Re: Project # 1010582

I am writing to voice my opposition to the Proposed Edith Waste Transfer Station at 4600 Edith NE. I ask that my letter be part of the public record.

Subject: Project # 1010582–Edith Transfer Station–Planner Analysis/Recommendation

Figure 36: North American Bicycle Facility Selection Chart (King, Michael. (2002).

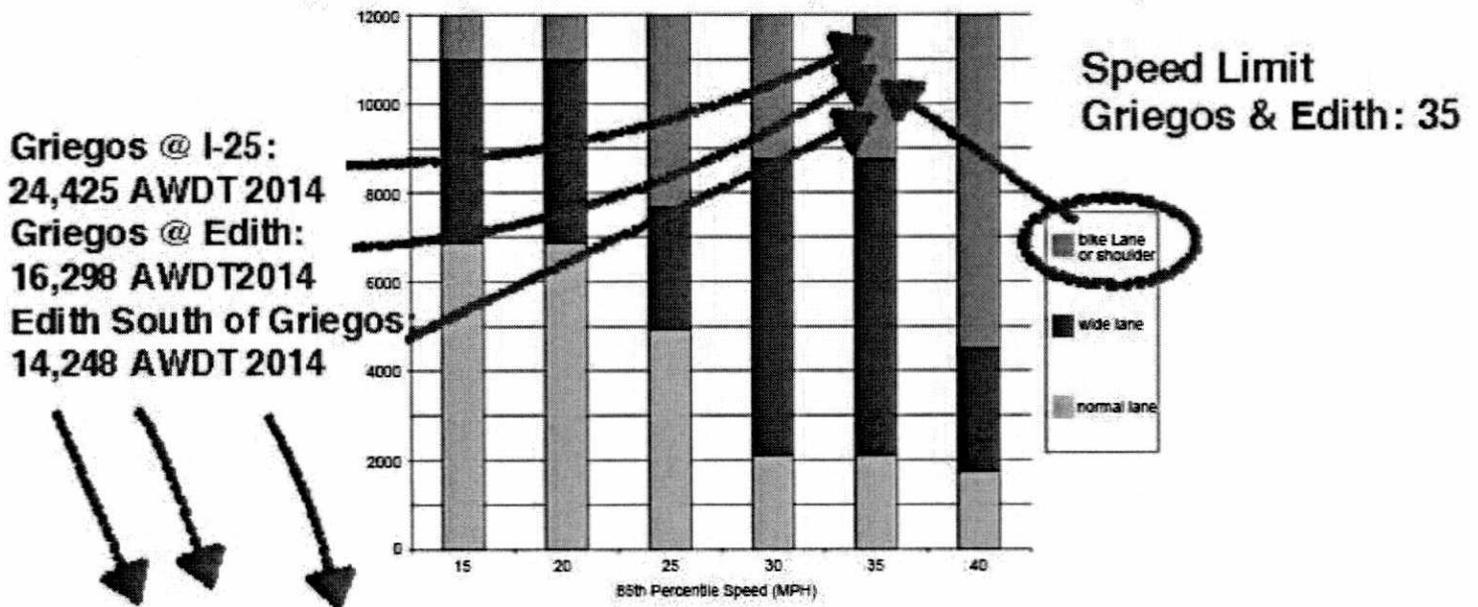
The City adopts this table, **Figure 36**, as its guidance for determining the appropriate facility type. In the future, traffic volume and road speeds may be different from the conditions when this plan was adopted. When new bikeways and trails facilities are being planned, designers should consult this table to ensure that the proposed facility type is appropriate.

1. Restripe collector and arterial roadways (where designated on the Bikeways Map and per NACTO and AASHTO guidelines) to provide bike lanes, or minimum outside lane width of 14 feet. **Note: Edith does not meet BTFP Guidance (ex: Figure 36)**
